Dear Editor and reviewers,

Reviewer 2

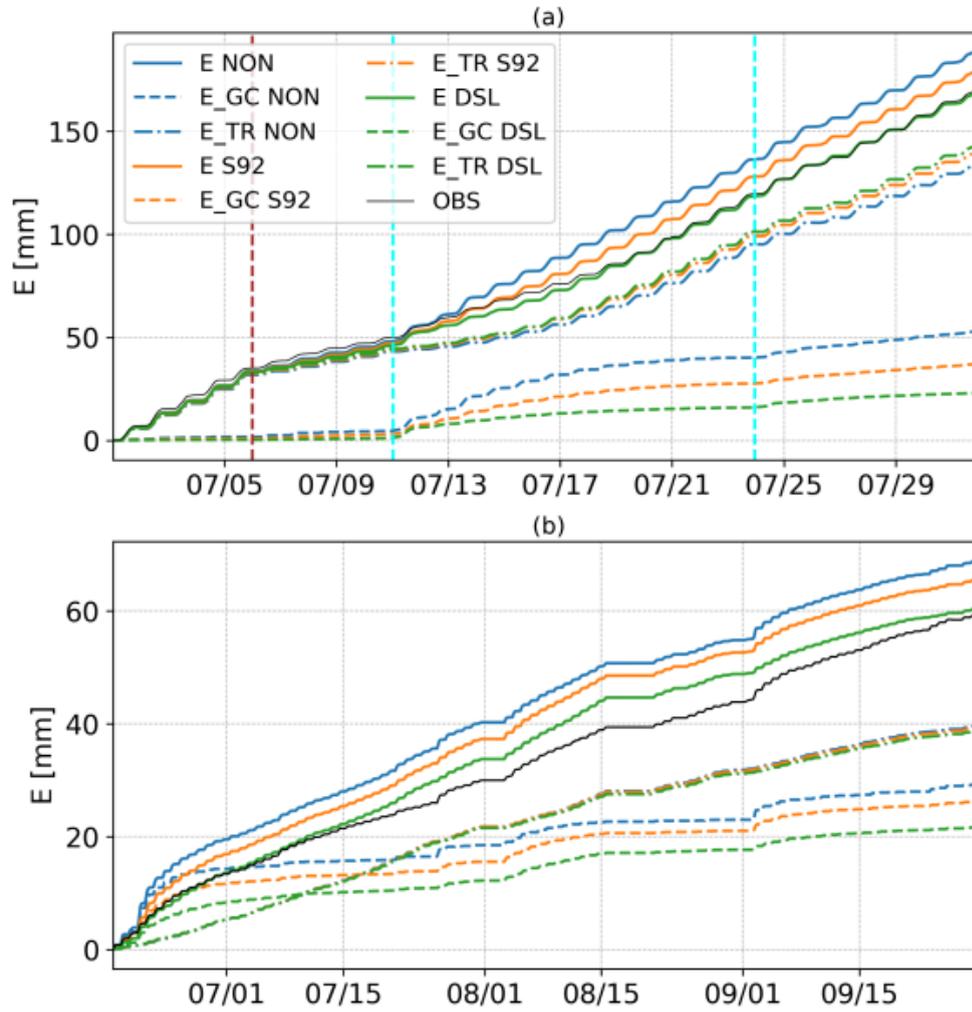
Several figures would benefit from improved visual clarity. For example, in Figure 10, different simulations are represented by solid and dashed lines that are difficult to distinguish, especially when curves overlap. Adding distinctive marker symbols (e.g., triangles, squares, circles) on the lines and enhancing color contrast would make the figure more accessible to readers. More generally, adopting a more coherent and visually appealing color palette throughout the manuscript would further improve figure quality.”

We have updated figures 10, 11 (see below) using symbols and more distinctive colors to make them more visible and figure 8 now uses the same colors as figures 6 and 7. We have maintained the rest of the figures as they were since the palette had already been chosen for large contrast between elements.
